INDESIT company

INC310GAID

Commercial code:

52220a0 Exploded views

0522067: SEALS FOR DOORS FOAMED AS ONE PIECE

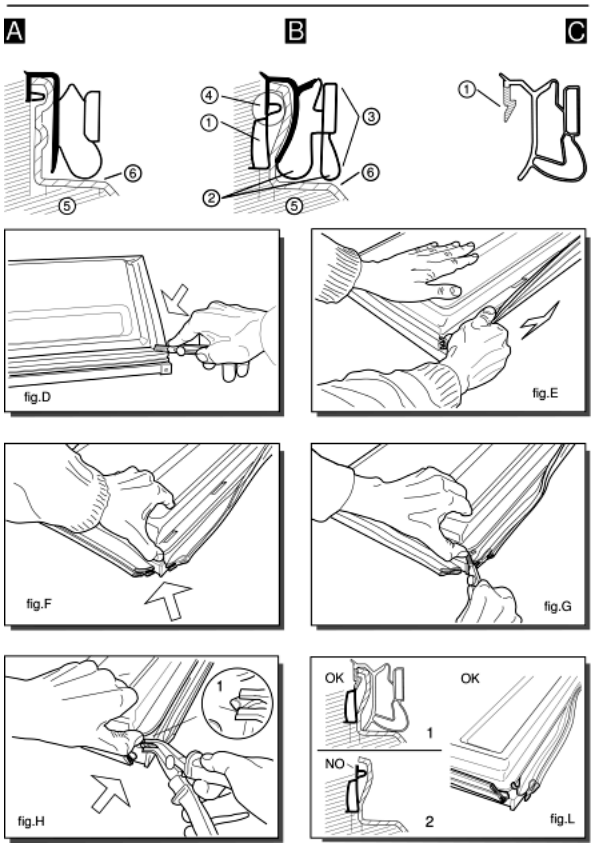
Various types of gaskets with different profile, as shown in figures (A) and (B), are used to fix the door (fig. A-5; B-5) and the inner door (fig. A-6; B-6) on the block foamed doors of combined freezers and refrigerators.
---Ilpea profile 245; 179; 412 (fig.A)
---Ilpea profile 287 (fig.B)
When replacing gaskets with profiles 245; 179; 412 these are fixed with screws (2 per corner) to the door.
Gaskets with profile 287 can not be used as spare parts but are designed to house the Ilpea type 900 gaskets (see figure C).
When replacing the gasket (287), once it is removed you will find a pocket (fig. B-1) between the door and inner door.
The rigid tooth (fig.C-1) of the gasket (900) is inserted inside between the pocket and the inner door, doing away with the need for screws.
Gasket with profile 287 is easy to identify since it has an exterior double edge (fig.B-2) which acts as a cushion when the door is closed.

To replace this gasket, follow these steps:
---Dismount the door and cut the four corners of the gasket along the joint (fig.D);
---lift the gasket and pull it carefully along its full length without tearing it (fig.E).
The purpose here is to detach the inner door slightly from the foam along the exterior edge for a depth equal to that of the gasket (fig.B-3);
---lift the corner of the inner door slightly, prising it up with your thumb (fig.F). Do not use a tool which might break the inner door;
---continue cutting the gasket inside the inner door for about 6 mm (fig.G);
---push in the tip of the pliers (type USAG N131) and pull outwards until you see the top edge of the pocket (fig. B-4) which is empty (fig.H-1);
---if you carry out this operation correctly (fig.L) you will be able to pull off the top edge of the pocket for the full length of the door.
If the gasket tears before the top edge (fig. L-2) you should repeat this operation from the other corner of the door.

---once the gasket (287), has been removed the space above the pocket (fig. L-1) can house the rigid tooth (fig. C-1) of the gasket 900.
When you fit this gasket ensure that it lies flush against the edge for the full length of the door.
If the rigid tooth is difficult to fit, eliminate any residues of foam between the door and the inner door in the gasket area.
fig.5131549A

n1030091: New control moulding on built-in mechanical 310 litre Indesit fridge-freezers

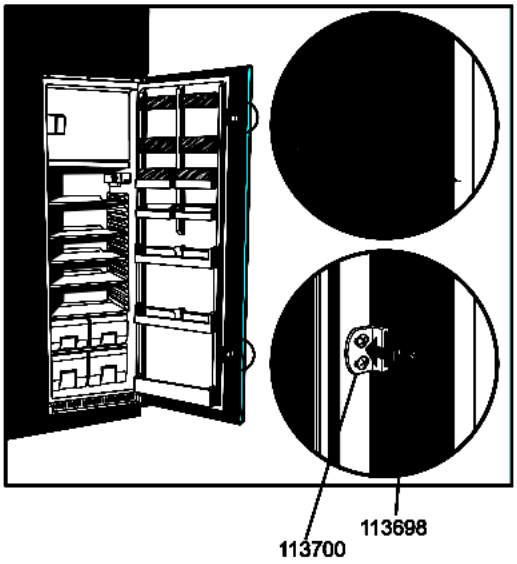
In June 2005 (serial no. 50606.0001) the Carinaro factory modified the control moulding on built-in 310 litre Indesit fridge-freezers (mechanical), unifying it with that of the electronic version in fixing and eliminating the control support.
The new moulding cannot be fitted on premodification models because also the control box and thermostat knob have been modified.
The moulding is fixed with two screws that are accessed by removing the hole covers.

118930 - CONTROL MOULDING LXHXD 328X60X22 (1-HOLE) INDESIT
099226 - THERMOSTAT KNOB WHITE
088521 - CAP RH WHITE
088522 - CAP LH WHITE

082176 - CONTROL MOULDING LXHXD 328X60X21 (1-HOLE) INDESIT
064626 - THERMOSTAT KNOB WHITE
064613 - CONTROL SUPPORT LXH 328X56X10
